A63 Castle Street Improvement, Hull

Environmental Statement Volume 1 Addendum 2
Yorkshire Water Drainage Network

Scheme Reference	TR010016
Application Document Reference	TR010016/APP/6.1
Author:	A63 Castle Street Project Team

Figure 1: Location of previous proposed long rising main route and outfalls and new proposed short rising route

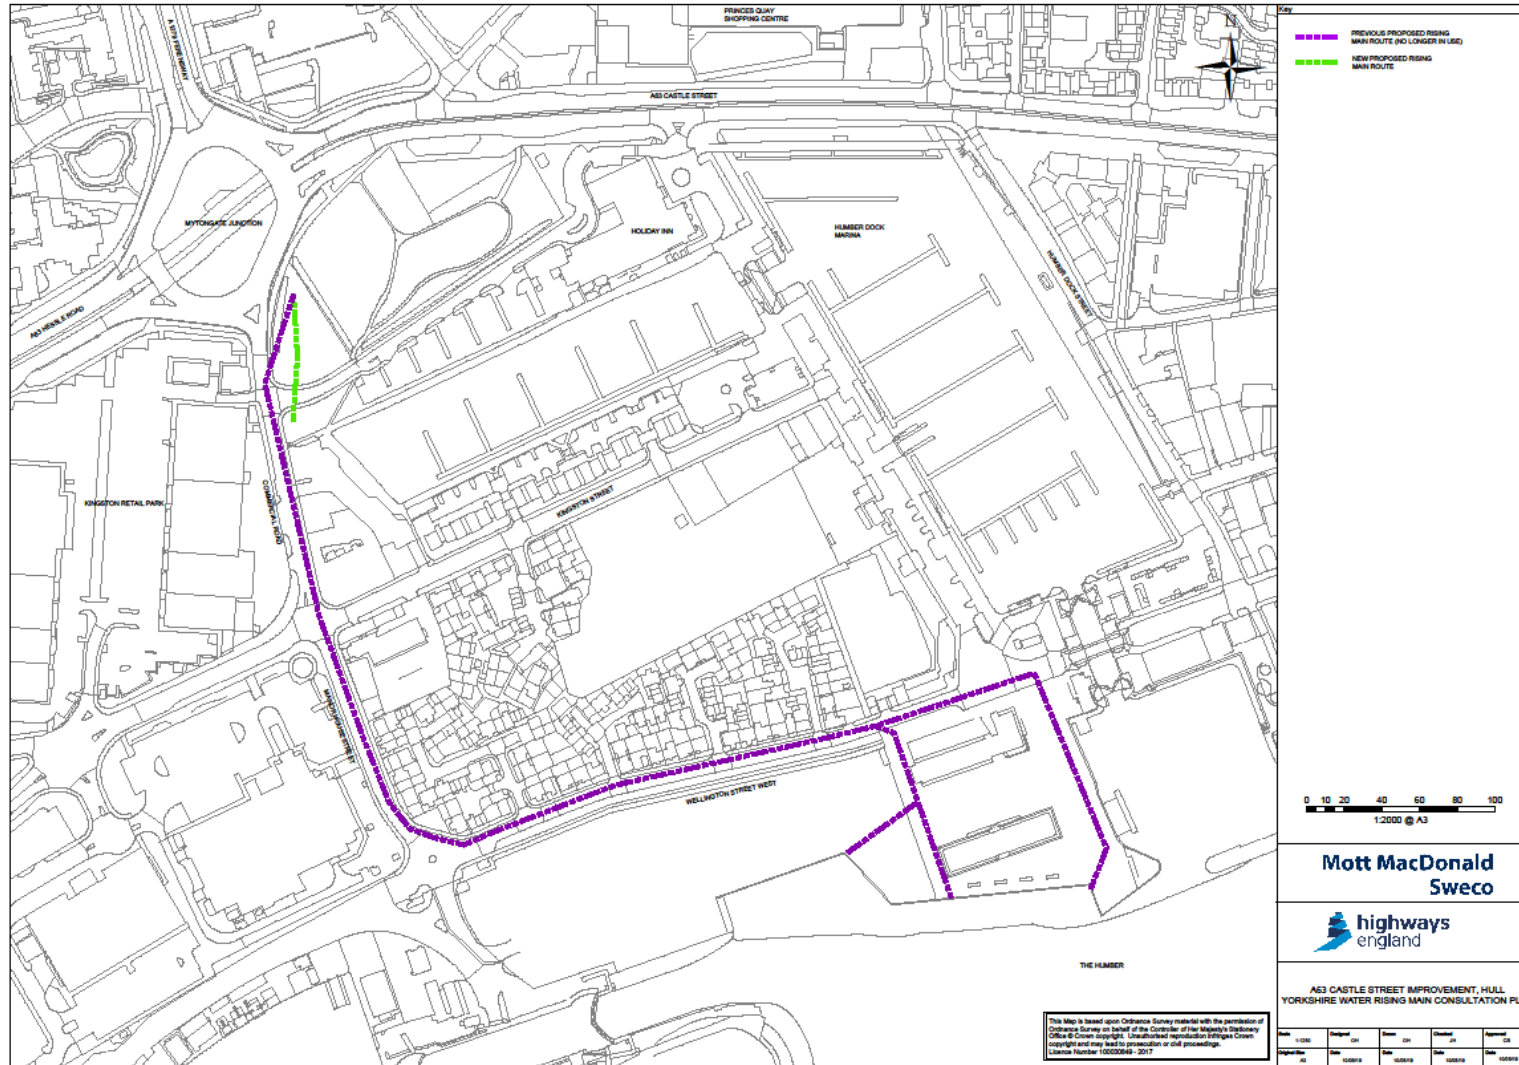
1.2.2 The alternative drainage option to usage of the YW network was to direct the discharge of surface water from the proposed underpass at Mytongate Junction, via a new long rising main to one of three outfall locations into the Humber as shown on Figure 1. The use of existing rock armour at the proposed outfall locations was proposed to prevent the discharge from scouring the river bed and creating silt plumes that could be detrimental to estuarine habitats and species.

- The long rising main route to the outfall - down Commercial Road, Manor House Street and Wellington Street West - can be removed
- A short rising main route from the pumping station across the Holiday Inn access road to a proposed manhole in the land adjacent to Commercial Road – is now required as shown on Figure 1.
- All three proposed outfall locations – can be removed

- The oil interceptors within the pumping station would no longer be required and therefore can be removed
